EAST GOSHEN TOWNSHIP PLANNING COMMISSION

Meeting Agenda

Wednesday, August 12, 2020

RE: 1303 Goshen Parkway – Preliminary / Final Land Development Jabil Finishing Plant Expansion – Fire Service Site Plan 1303 Goshen Parkway, West Chester, PA 19380 Mainstay Project Number: 19360

PRE-DEVELOPMENT DRAINAGE PLAN

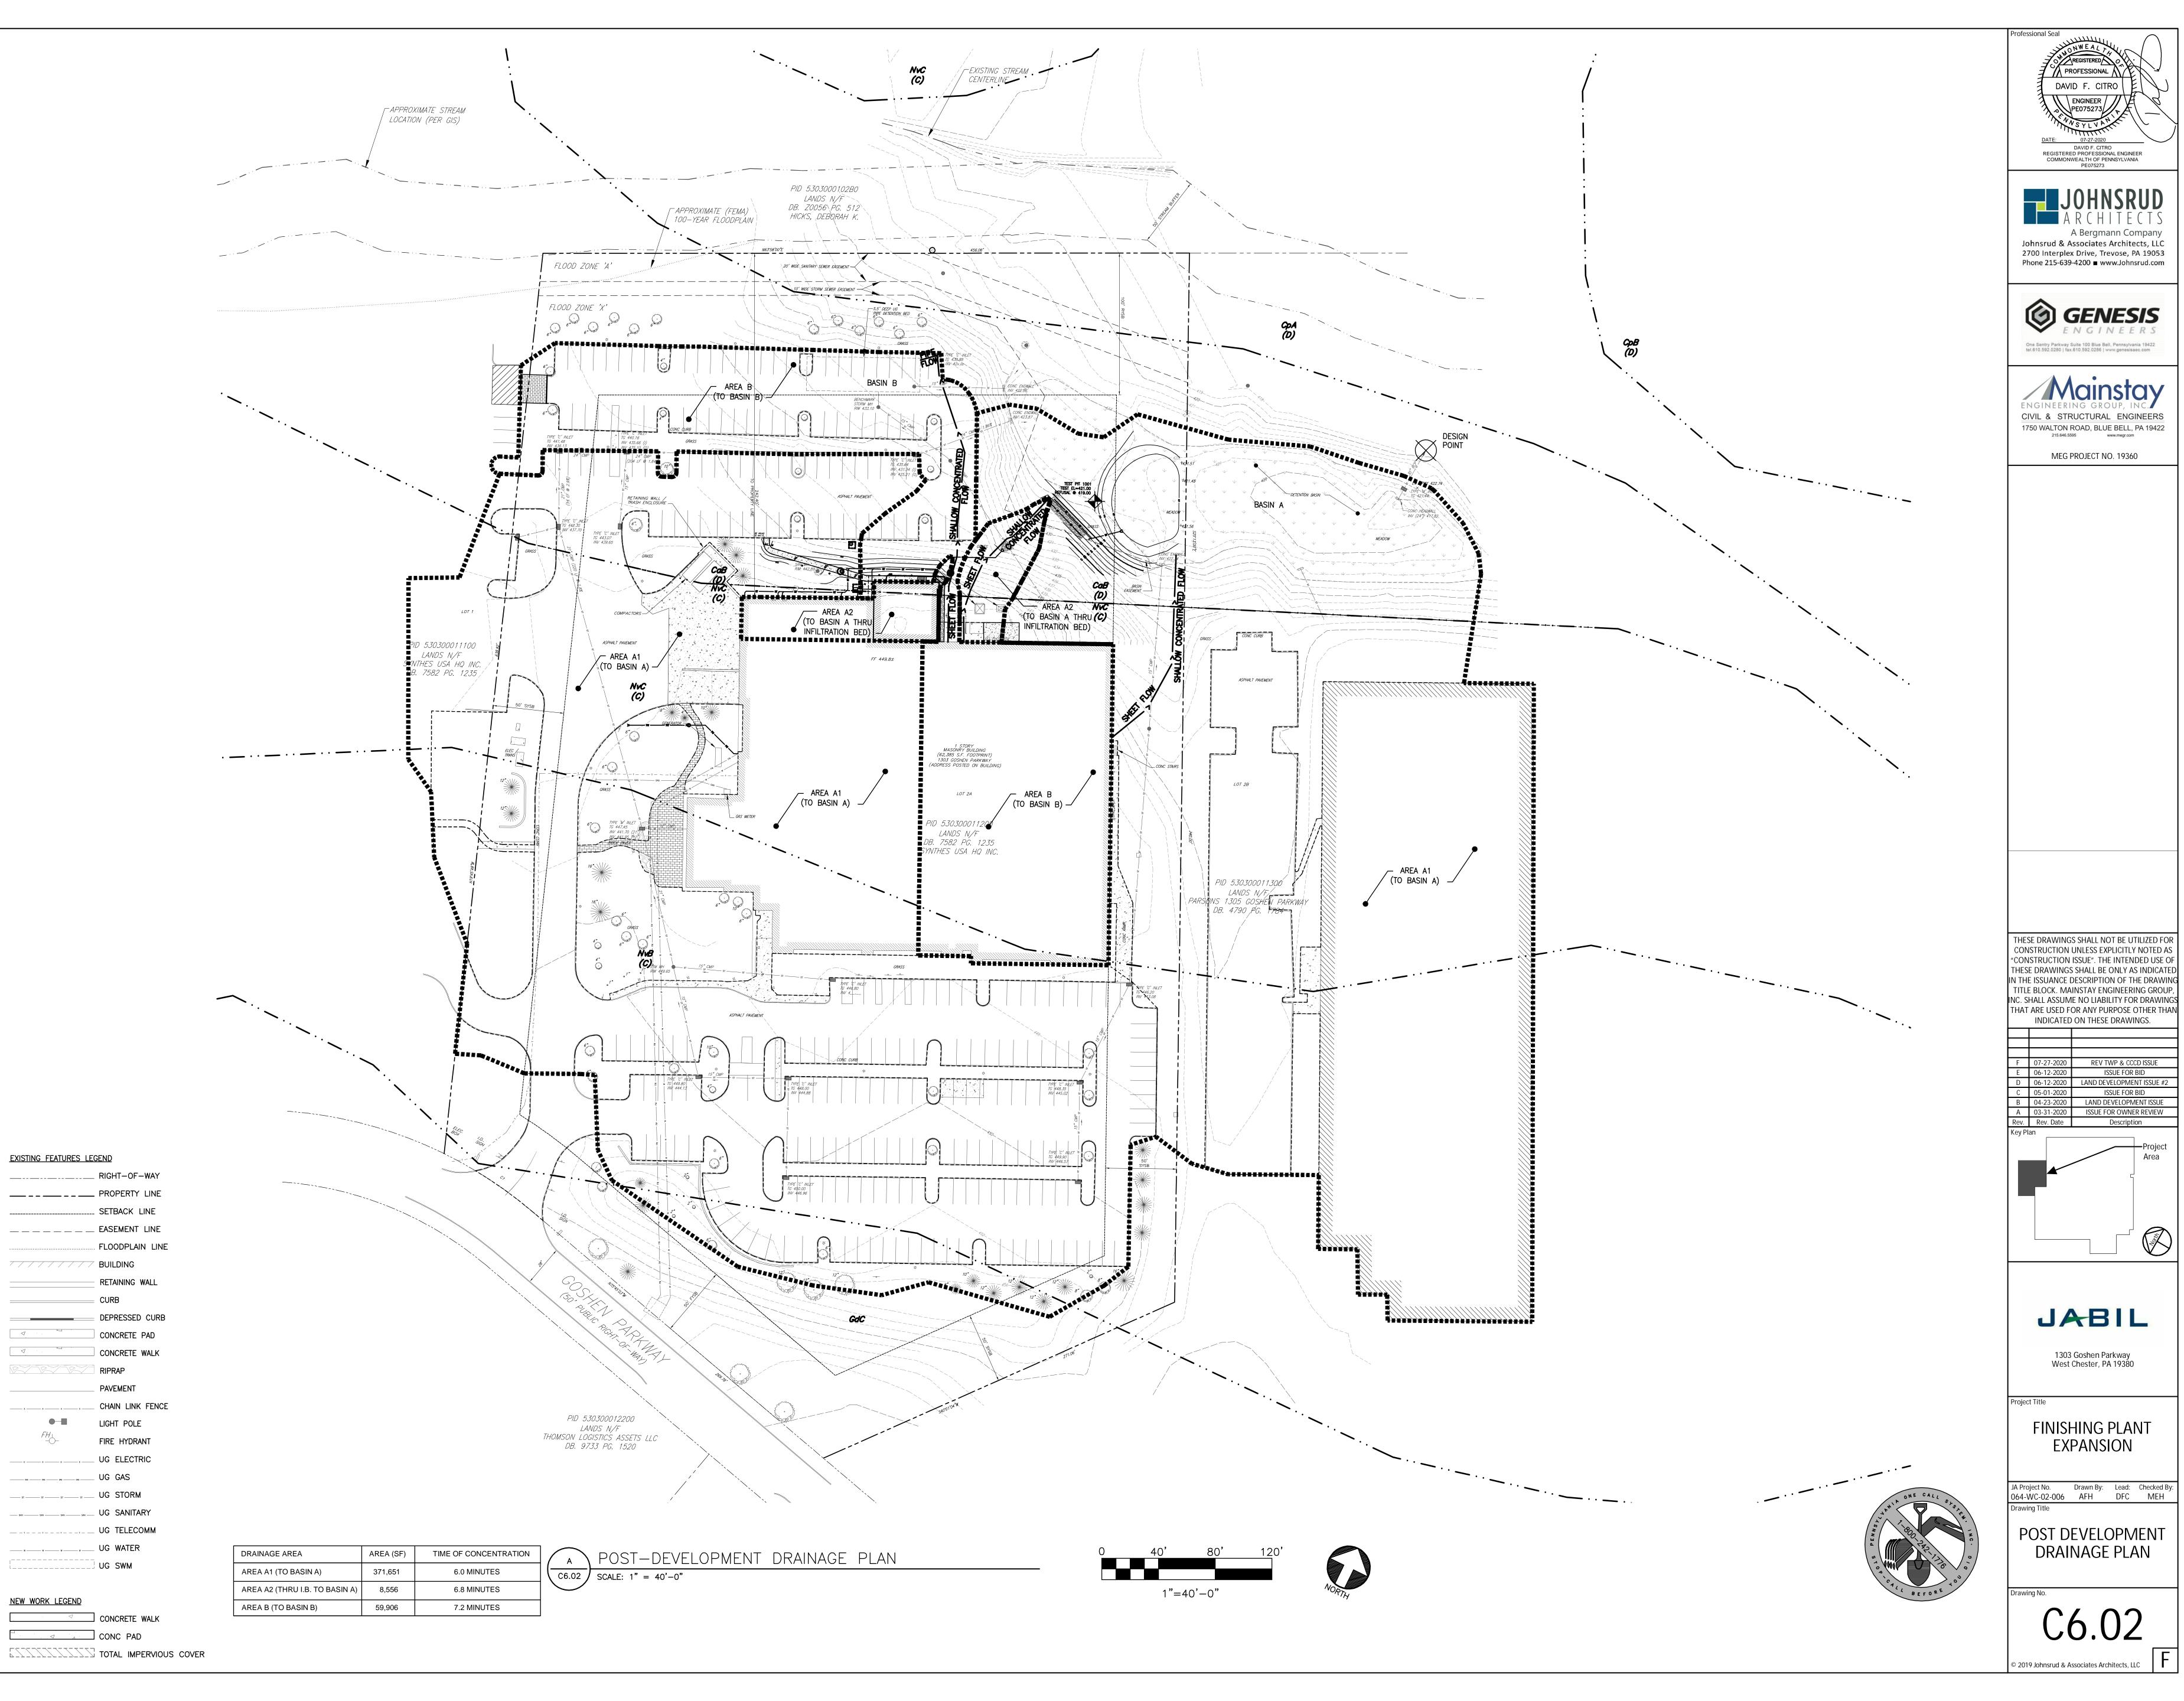
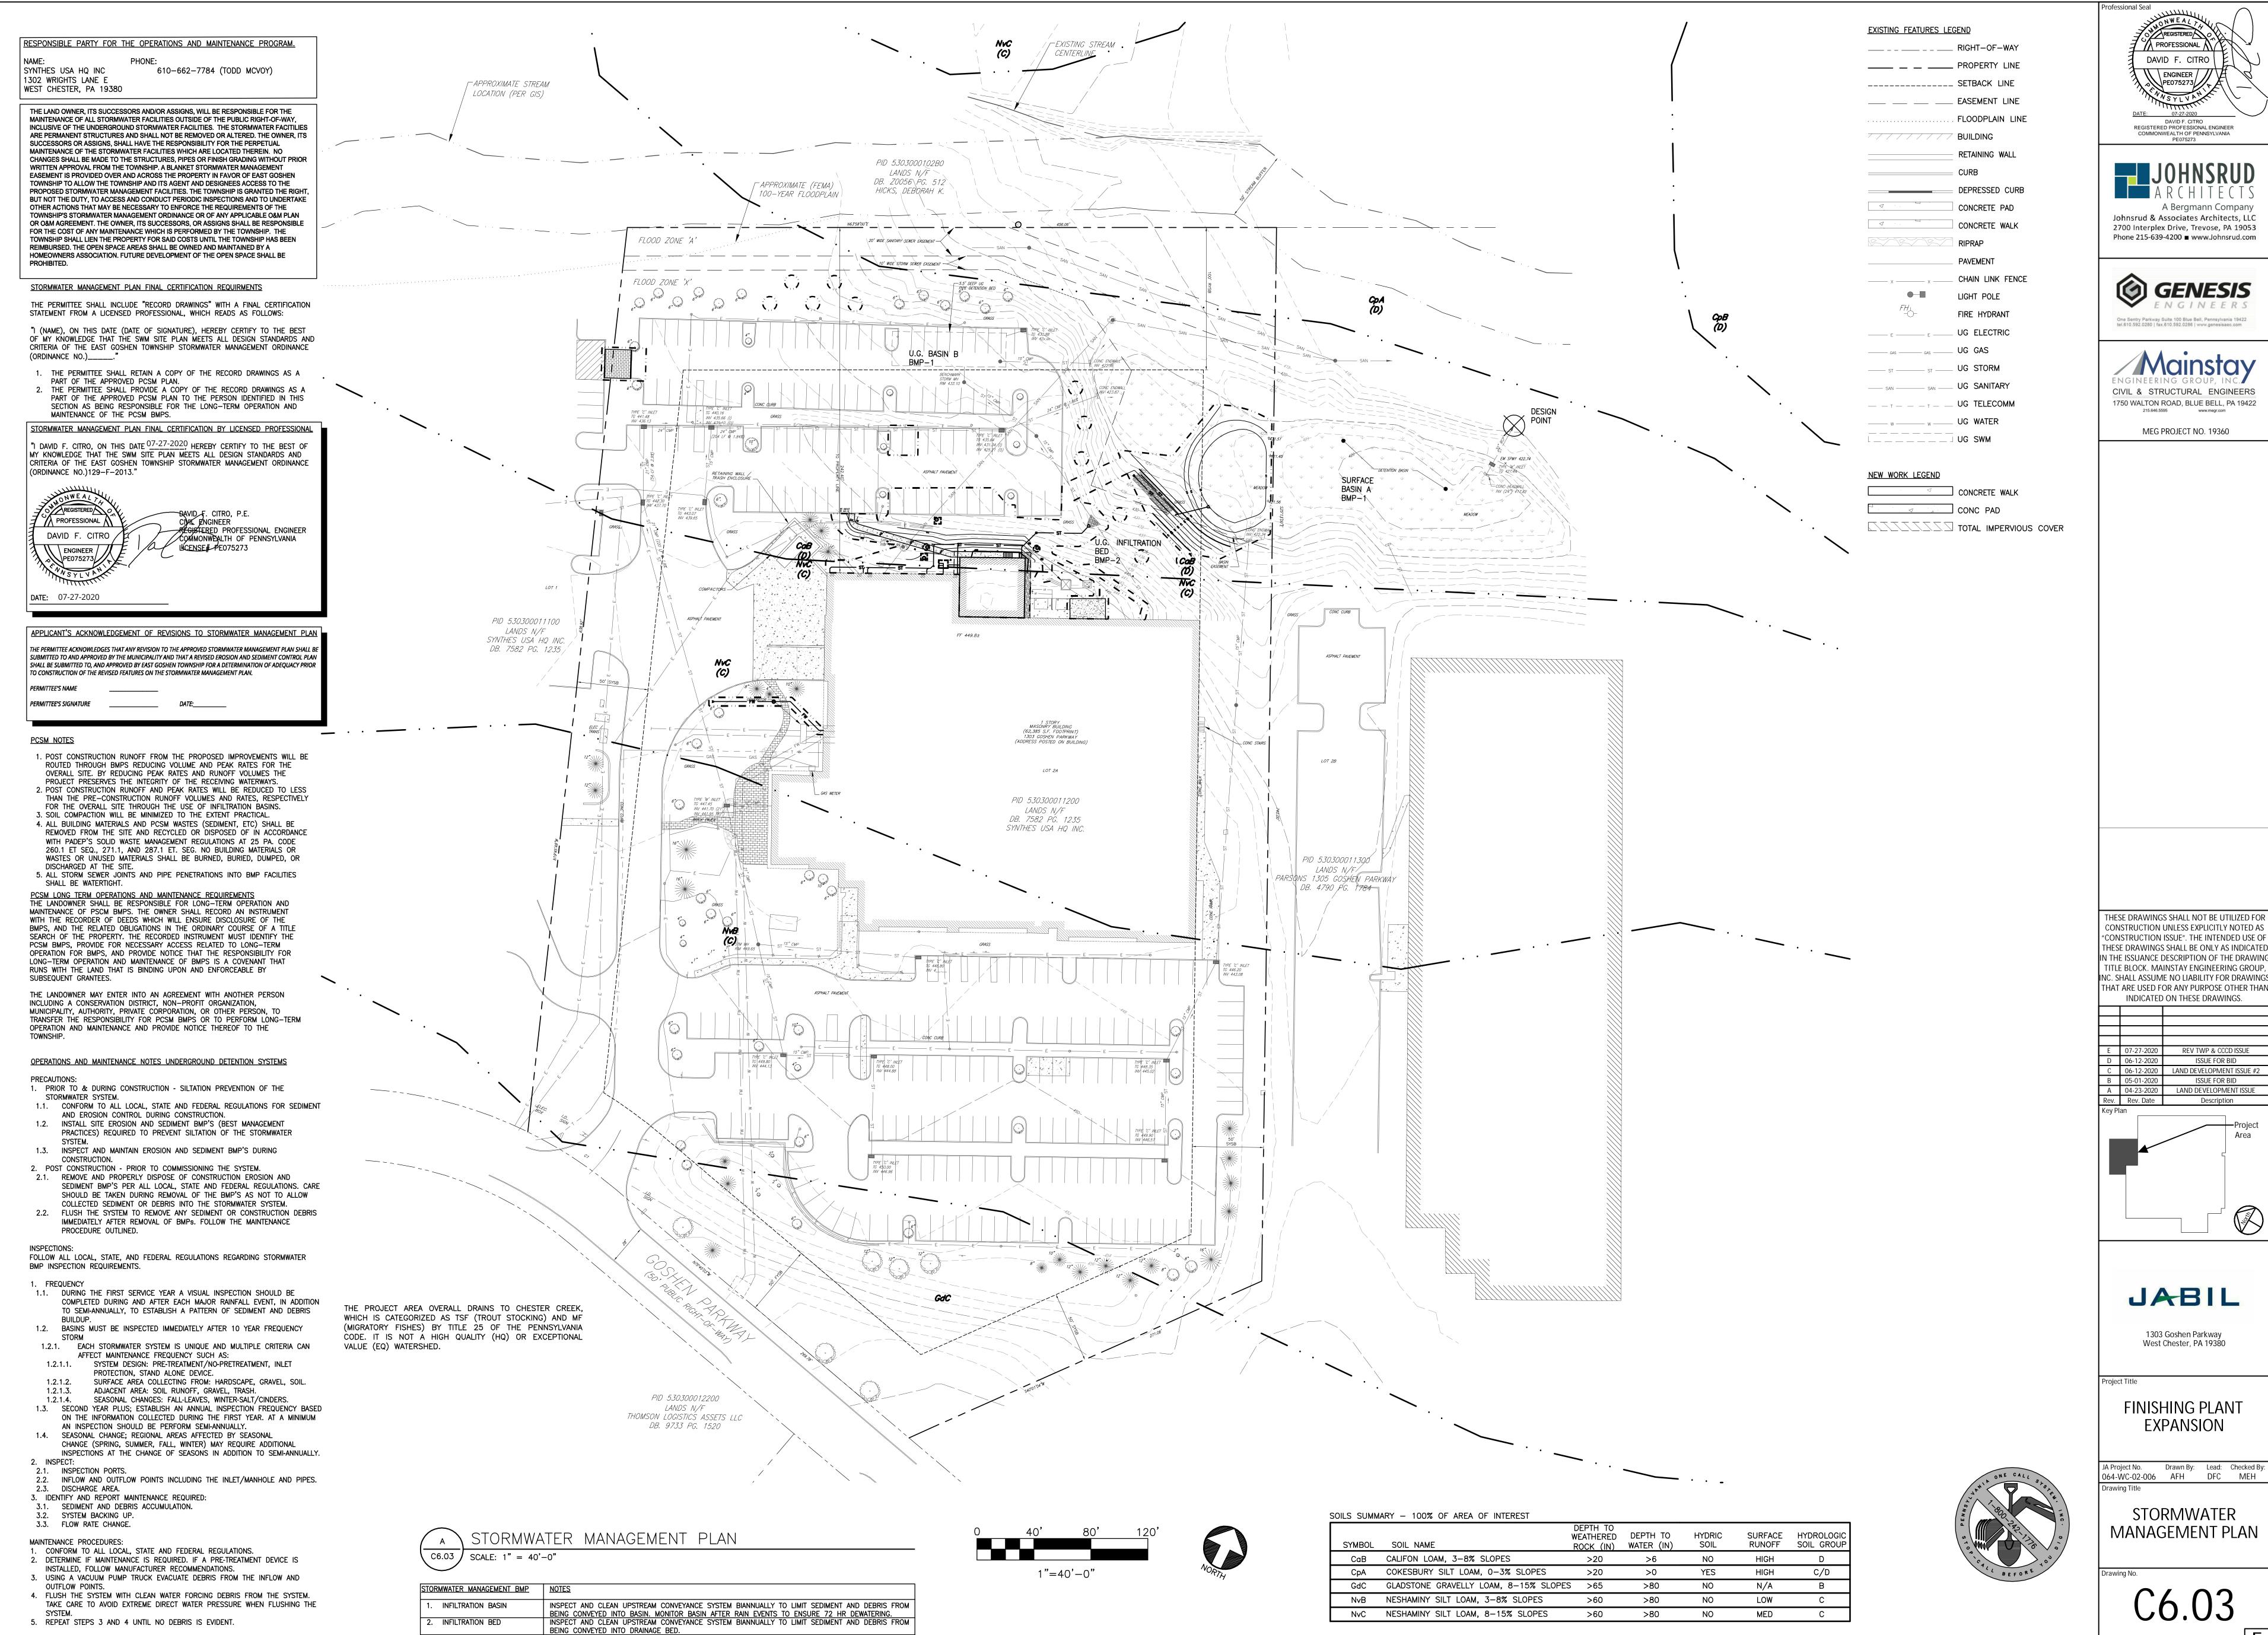
18. Please provide complete delineation of the flow paths used for calculating the time of concentration (Tc) for the predevelopment and postconstruction conditions. (§195-27.B(14))

Resolved. The applicant provided Tc flow paths on the drainage area plans.
